INITIAL FIRE SAFETY INSPECTION REPORT

Factory Name: L'esquire Limited

Inspected By: Md. Rafat Arefin, Md. Kamrul Hasan & Tanvir Jubayer Rahman

Date: 25 January 2024

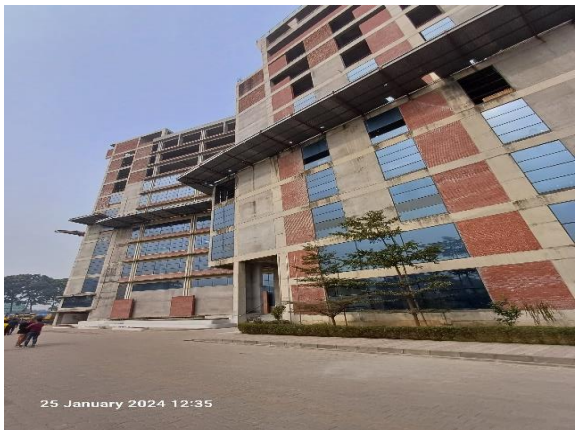
4	Fire Rated Construction	<p>The boiler and MEP Accessories Storage rooms are not separated by fire rated construction due to cable tray penetrations.</p> <p>(Ground Floor of Utility Building)</p>	<p>Any room or space housing boilers or other heat producing equipment shall be separated from other occupancies by a minimum 1 hour construction or by a minimum spatial separation of 3 m (10 ft) where located exterior to the building.</p>	Within 3 months
---	-------------------------	-----------------------------------------------------------------------------------------------------------------------------------------------------------------------------------	-------------------------------------------------------------------------------------------------------------------------------------------------------------------------------------------------------------------------------------------------	-----------------

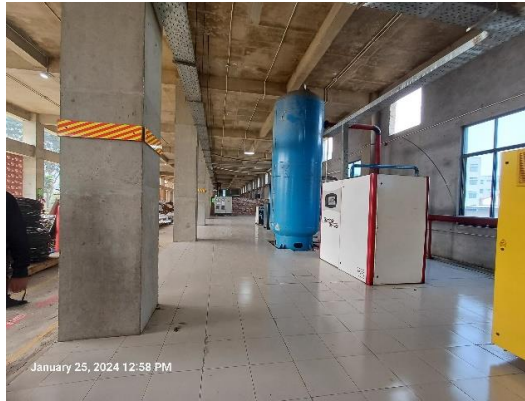
9	Fire Rated Construction	<p>Rooms used for combustible storage are not separated by fire rated construction with the compressor area on the 1st floor.</p> <p>(Utility Building)</p>	<p>Separate the dedicated storage rooms by minimum 1-hr fire-rated construction. Provide 0.75 hr. fire rated door and seal all penetrations and openings by 0.75 hr. (45 Minutes) fire rated fire rated barrier construction.</p>	Within 3 months
---	-------------------------	--------------------------------------------------------------------------------------------------------------------------------------------------------------------	-----------------------------------------------------------------------------------------------------------------------------------------------------------------------------------------------------------------------------------	-----------------

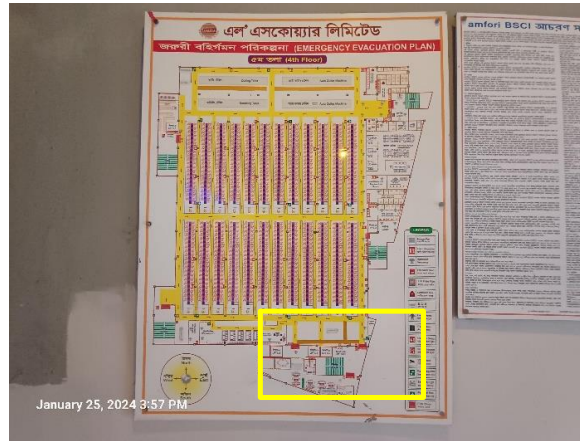
13	Means of egress	<p>South side portions of the production building (Office Rea) have single exit at all floors level of the 10 storied building.</p> <p>(Production Building)</p>	<p>The number of means of egress from any floor, story or portion thereof shall not be less than 2 except where a single exit is permitted by RSC guidelines 6.6.2, a single means of egress is permitted by RSC guidelines 6.6.5 or where a greater number is required by RSC guidelines 6.6.3.</p> <p>Or, Modify arrangement to provide/connect the portion with main building through horizontal exit (if possible)</p>	Within 3 months
----	-----------------	-------------------------------------------------------------------------------------------------------------------------------------------------------------------------	----------------------------------------------------------------------------------------------------------------------------------------------------------------------------------------------------------------------------------------------------------------------------------------------------------------------------------------------------------------------------------------------------------------------------	-----------------

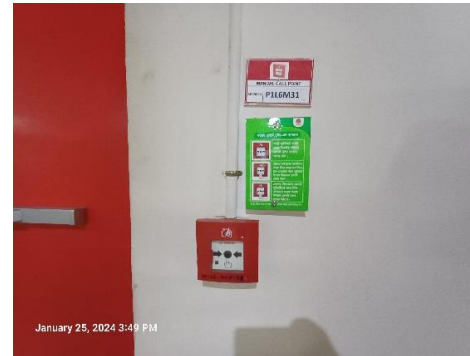
17	Fire Alarm & Detection system	Automatic fire alarm and detection system installation has been found complete which requires detailed review to confirm compliance with NFPA 72 and The RSC Technical Guidelines (Standard).	Submit the fire alarm system design to RSC for review. Once the design is reviewed, install and modify the fire detection and alarm system throughout the buildings in accordance with review comment, RSC Technical Guidelines (Standard) and NFPA 72. After installation the owner shall conduct internal testing and commissioning and then contact the RSC for witness of final acceptance testing. Also inspect, test and maintain the fire alarm system, and keep written records on-site, in accordance with Table-14.3.1 of NFPA 72.	Design Review within 2 months and installation/modification within 4 months
----	-------------------------------	-----------------------------------------------------------------------------------------------------------------------------------------------------------------------------------------------	----------------------------------------------------------------------------------------------------------------------------------------------------------------------------------------------------------------------------------------------------------------------------------------------------------------------------------------------------------------------------------------------------------------------------------------------------------------------------------------------------------------------------------------------	-----------------------------------------------------------------------------
